# Service Bulletin

SEPTEMBER 1957 NO. 328

## Studebaker and Packard Clipper

### ENGINE OIL LOSS AT ROCKER ARM COVERS - 1957 STUDEBAKER AND PACKARD V-8 ENGINES

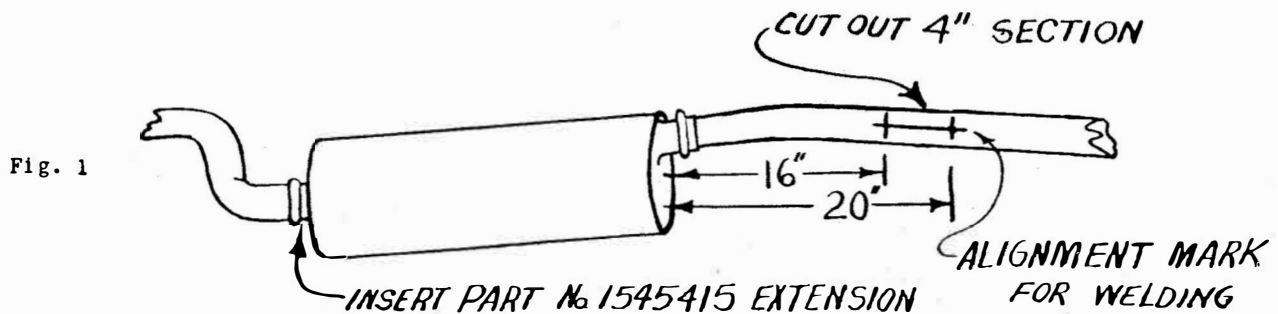
In some of the 1957 Packard Clipper Sedan and 1957 Studebaker President models, a vibration is sometimes noticeable on acceleration at 14 to 15 m.p.h. and again in the 28 to 32 m.p.h. range. A slight up-grade pull during the speeds mentioned will accentuate the noise condition.

From the front or forward plate of the mufflers, measure forward 16 inches and scribe

a mark, measure to 20 inches and scribe another mark. Scribe a straight line lengthwise on the front exhaust pipe to pass through the vertical marks at 16 and 20 inches. This will insure proper alignment for welding. The layout and markings as previously described should be applied alike to both right and left front exhaust pipes. See Fig. 1.

Remove the outlet pipes from both mufflers, remove both mufflers and front exhaust pipes, leave outlet tubes in place on the rear supports.

Cut the four inch section out of each front exhaust pipe at the 16 and 20 inches forward of mufflers as previously marked, butt the ends of the exhaust pipes together in line with the lengthwise mark, to insure alignment, and weld the front and rear sections together.

Install the two new Muffler Outlet Tube Extensions, Part No. 1545415 in each muffler rear outlet. Install the mufflers, front exhaust pipes and rear outlet pipes in place.

Install the forward U-bolts and saddles, as previously described (not attached to the fly-wheel housing brackets). Install the U-bolts and saddles at the front and rear of the mufflers; also attach the rear supports, which are now rearward four inches, directly to the outlet pipes. Two new U-bolts and saddles are used to secure the outlet tube extensions at rear of the mufflers.

Fig. 2

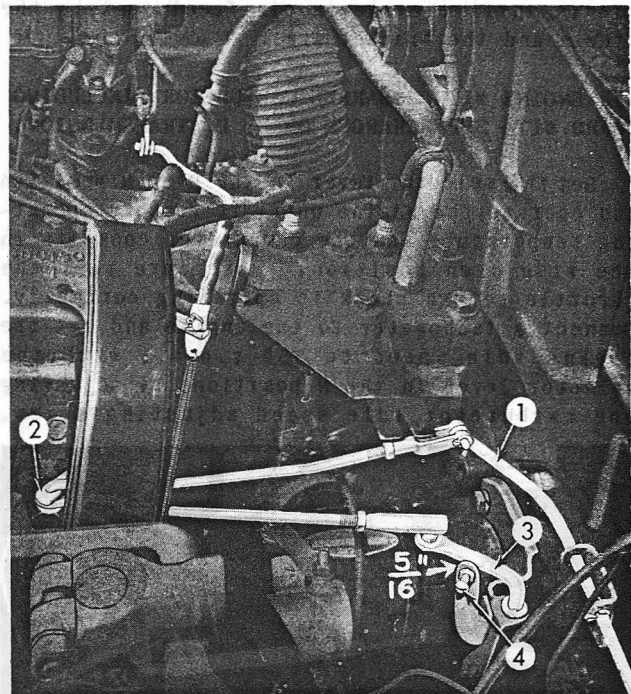
In a great number of cases unsatisfactory Flightomatic transmission operation can be traced to improperly adjusted throttle linkage. In some instances transmissions have been found to have the throttle linkage adjusted to provide insufficient control pressure which allows slippage and early failure of bands and clutches. In other instances, transmissions have been found to have the throttle linkage adjusted to provide too high a control pressure with the results of bumpy and relatively high upshift speeds.

Set the selector lever in the P or N position and operate the engine until it reaches operating temperature and the carburetor choke is in the wide open position. Disconnect the rod which connects the accelerator bracket (1, Fig. 2) to the auxiliary bellcrank (2) by removing the clevis pin from the clevis.

Disconnect the rod which connects the main bellcrank (3) to the auxiliary bellcrank (2) by removing the ball joint stud from the main bellcrank lever. Adjust the screw (4) to provide a 5/16" (7.94mm.) gap between the bellcrank and the pad. A 5/16" drill should be used as a gauge.

Adjust the ball joint on the main bellcrank-to-auxiliary bellcrank rod until the ball joint stud freely enters the hole in the main bellcrank lever. During this adjustment the carburetor idle speed screw must be against its stop and the 5/16" gap at the bellcrank must be maintained.

Place the selector in the D position and operate the engine at 1000 r.p.m. with the rear wheels held stationary by the foot brake. Adjust the length of the main bellcrank-to-throttle valve outer lever rod to obtain 80-85 p.s.i. Stop the engine and remove the pressure gauge and install the 1/8" pipe plug.

Hold the accelerator bracket arm approximately 3 7/8" (9.82cm.) from the fire wall and,

adjust the accelerator-to-auxiliary bellcrank rod clevis until the clevis pin freely enters the clevis and the bracket arm.

Fig. 3

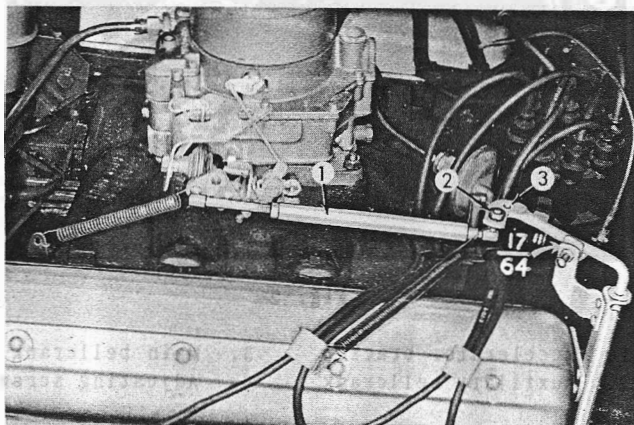
Set the selector lever in the P or N position and operate the engine until it reaches operating temperature and the carburetor choke is in the wide open position. Make sure that the throttle return check is operating correctly. Connect a tachometer to the engine and set the engine idle speed to 550 r.p.m., with the selector lever in the N position, by adjusting the carburetor idle speed adjusting screw.

Set the stop on the bellcrank to provide 17/64" (6,747mm.) gap between the bellcrank pads (see Fig. 3). A 17/64" drill should be used as a gauge. After the stop has been adjusted, hold in this position. Make sure that the carburetor to-bellcrank rod ball joint is in the inner hole of the bellcrank pad (toward the center line of the engine) and that the ball joint is on the underneath side of the bellcrank. NOTE: The carburetor-to-bellcrank rod ball joint should be in the outer hole of the bellcrank pad (away from the centerline of the engine) and the ball joint should be on the upper side of the bellcrank on cars equipped with a supercharger. Adjust the carburetor to bellcrank rod until the idle speed adjusting screw just begins to leave the stop.

Adjust the length of the bellcrank-to-throttle valve outer lever rod to obtain 80-85 p.s.i. (95-100 p.s.i. on cars equipped with supercharger or heavyduty transmissions such as used on police cars, etc.). Stop the engine and remove the pressure gauge and install the 1/8" pipe plug.

Set the stop on the bellcrank to provide 17/64" (6,747mm.) gap between the bellcrank pads (see Fig. 3). A 17/64" drill should be used as a gauge. Make sure that the carburetor-to-bellcrank rod ball joint is in the outer hole (away from the centerline of the engine) and that the ball joint is on the underneath side of the bellcrank lever. Adjust the carburetor-to-bellcrank rod until the idle speed adjusting screw just begins to leave its stop.
